CITY OF KELOWNA **MEMORANDUM**

APPLICATION NO. Z08-0030

TO REZONE PORTIONS OF THE SUBJECT PROPERTIES FROM THE RU6 - TWO DWELLING HOUSING ZONE TO THE RM5 -MEDIUM DENSITY MULTIPLE HOUSING ZONE AND P3 - PARKS AND OPEN SPACE IN ORDER TO ACCOMMODATE 41

Proposed 41 Unit Assisted Living Building 1230 Brookside Dr. Lot 1 Plan 4386,

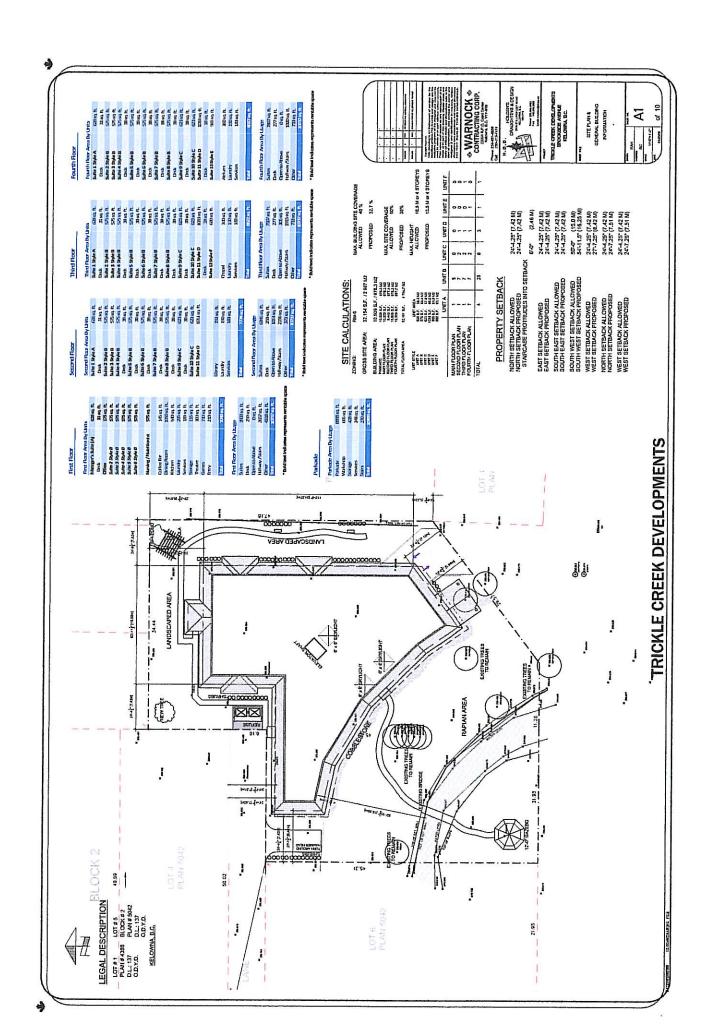
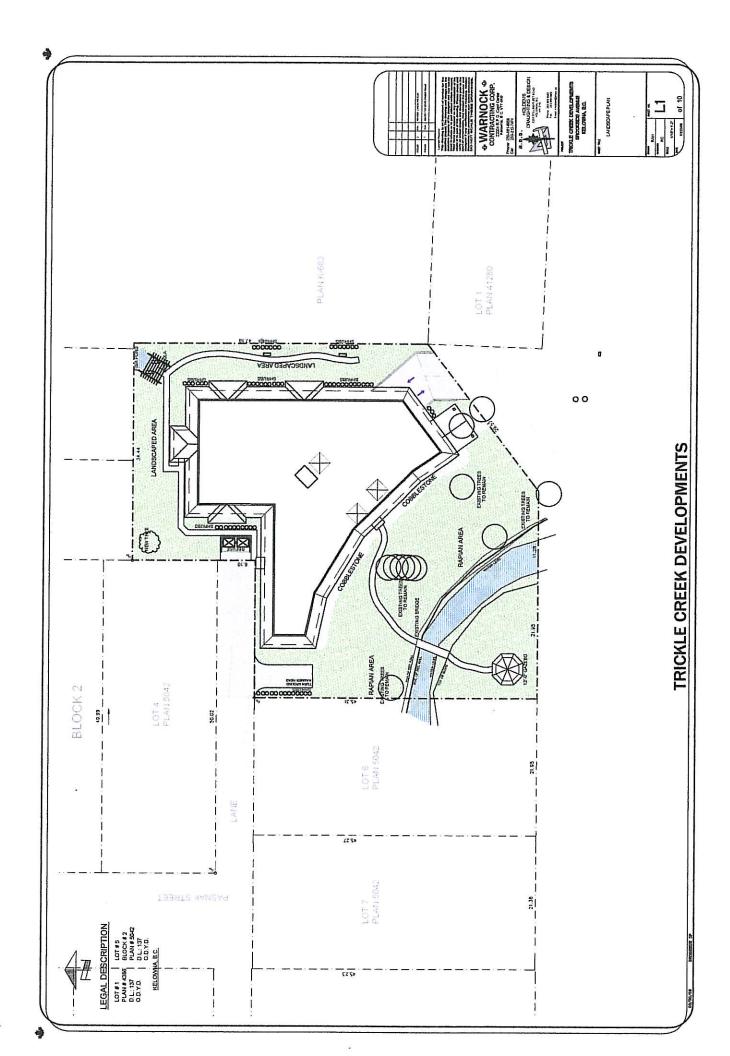
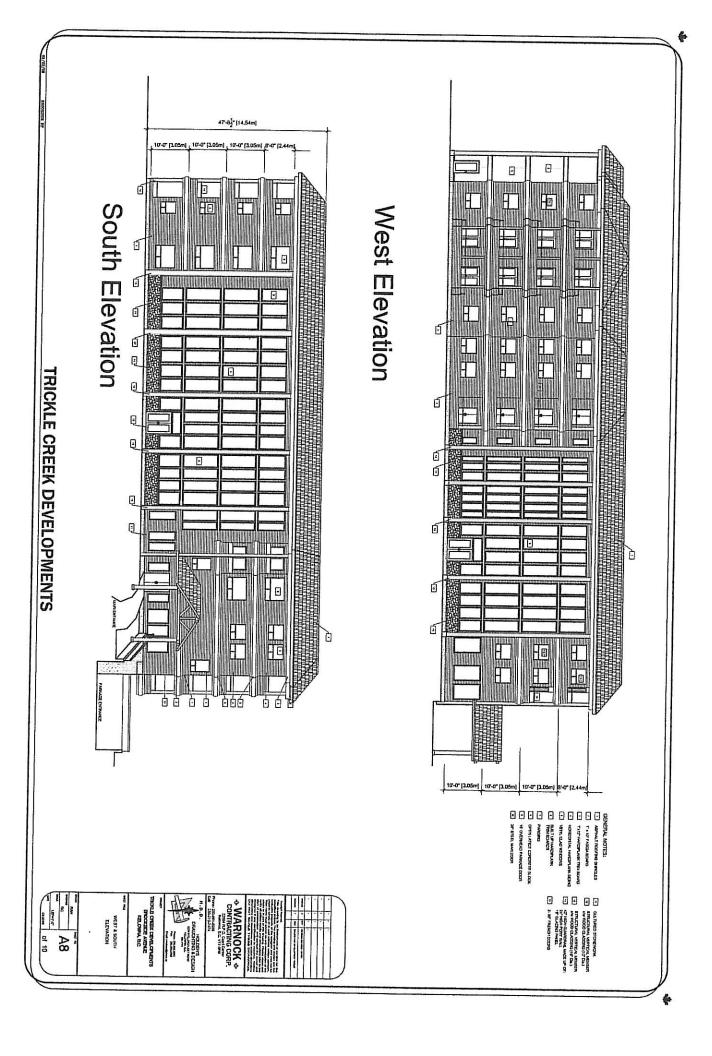
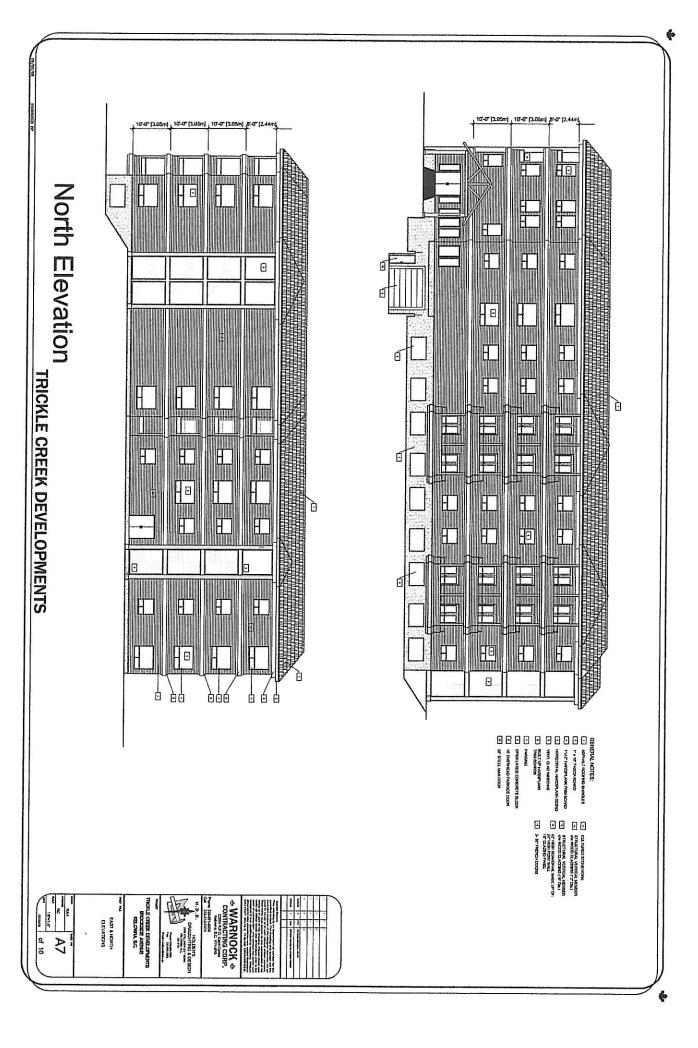
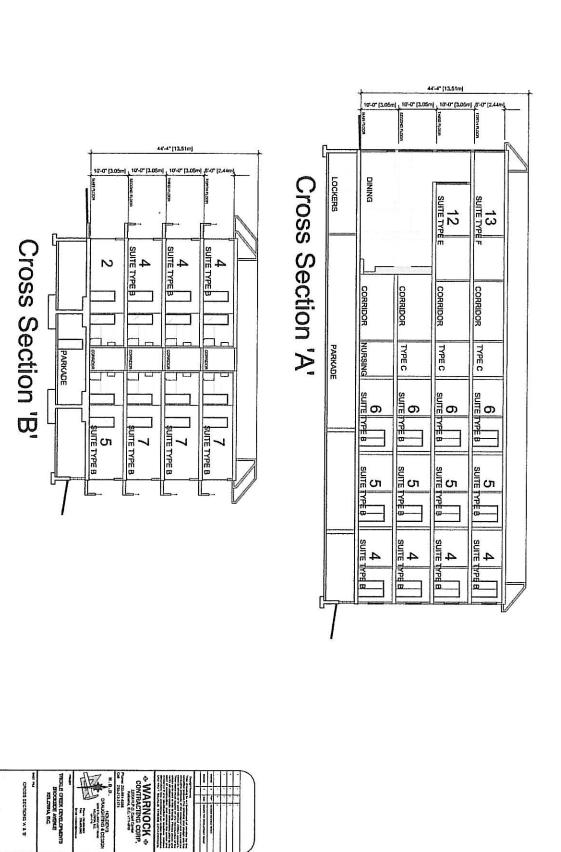
Environment Manager 2008-05-30 2008-06-05 The Environment Division is generally satisfied with the proposed site plan (Sheet A1, Trickle Creek Developments, dated March 20, 2008) submitted by Warnock Contracting Corp; however, there are some concerns that need to be addressed as follows:

- The Environment Division requests that the proponent provide a draft no build/no disturb Section 219 Restrictive Covenant, which is to be registered under the Land Title Act against the title of the subject property to effectively preserve the Mill Creek Riparian Management Areas.

- " The proponent needs to provide a draft Section 219 Restrictive Covenant to be registered under the Land Title Act against the title of the subject property to save harmless the Province and the City of Kelowna from damages due to flooding.

- " The Environment Division requests that the proponent provide a Riparian Restoration Landscape plan that details how the riparian area will be naturalized to sustain aquatic habitat, since this area will be covenanted as a no build and no disturb area. The riparian restoration is also important in the areas where several buildings will be demolished to make room for the proposed development. The landscape plan must be approved and stamped by a Registered Professional Biologist.

Before DP approval we need a detailed code analysis and drawings pertaining to occupancy (group C or group B2), type of construction, Fire Department access, access route and route design, exiting (there are dead end corridors), fire flows, there are limited city hydrants in the area so hydrant placement needs to be shown with consideration to

All retaining walls and lot grading design to be dealt with prior to DP approval. Registerted architect to prepare DP and BP drawings. Parkade level appears to be underground, not in compliance with 1:200 flood plain construction requirements, to be addressed prior to issuance of DP. Nursing room designated on 1st floor indicates possible care facility service which building is to be designed as a Group B.2 classification not a Group C classification, registered professional to clarify this issue prior to issuance of DP. Additional exit stair shaft required to meet requirements of BCBC 2006 (dead end corridors). Main entrance appears not to be disabled accessible.

Dry. 2

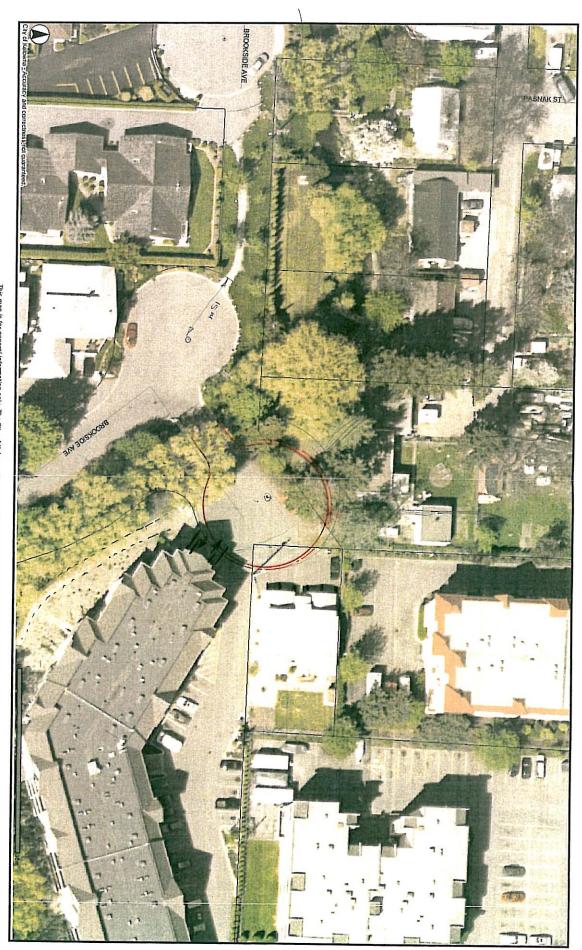
- (a) The applicant will be responsible for upgrading Brookside Avenue to a local residential cul-de-sac standard (SS-R17), for reference two sketches have been attached showing potential layouts. Drawing 1 will require addition road dedication from 1250-1252 Brookside Drive and Drawing 2 is an option which all additional road dedication required would be attained from the subject property. Bonding security will be required from the applicant for the construction of the cul-de-sac, including curb and gutter, pavement widening, landscaped boulevard complete with underground irrigation system, street lights as required and relocation or adjustment of existing utility appurtenances if required to accommodate the upgrading construction. The City has collected deferred revenue which can be used towards the costs of the cul-de-sac construction.
